Town of Parker Community Development Department
Development Review Division
Attention: Stacey Nerger

Application Type: **Site Plan – Non-Residential**
Status: **First Referral**
Application Name: Douglas 234 F6 AMD 2 L8A - Les Schwab Tire
Case/AP#: **SP23-054**
Referral Received: July 28, 2022
Comments Due: August 18 ,2022

Review date: **August 7, 2022**
Plan reviewer: **Randall L. Capra, rcapra@parkeronline.org**
Phone: 303.805.3163

TOWN OF PARKER FIRE/LIFE SAFETY:

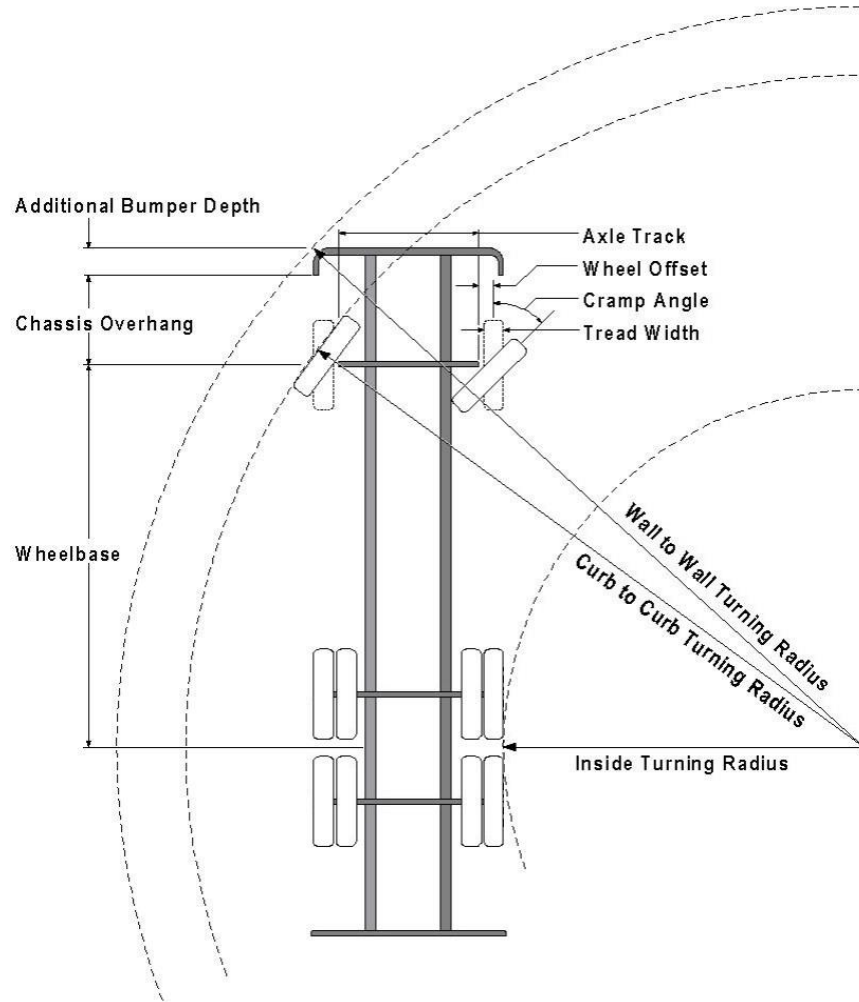
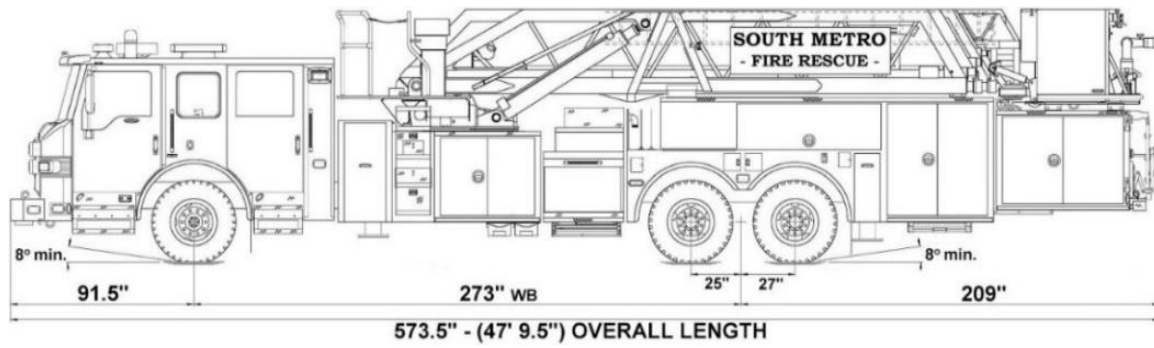
6. The applicant shall provide an additional NO PARKING – FIRE LANE signage in the location shown below; this location is on the south side of the access road just south of the building. See item #5 above specific to this issue.

Not satisfied with the second submittal; issues were not addressed. Satisfied; the applicant as noted, acknowledged, or addressed with the fourth submittal.
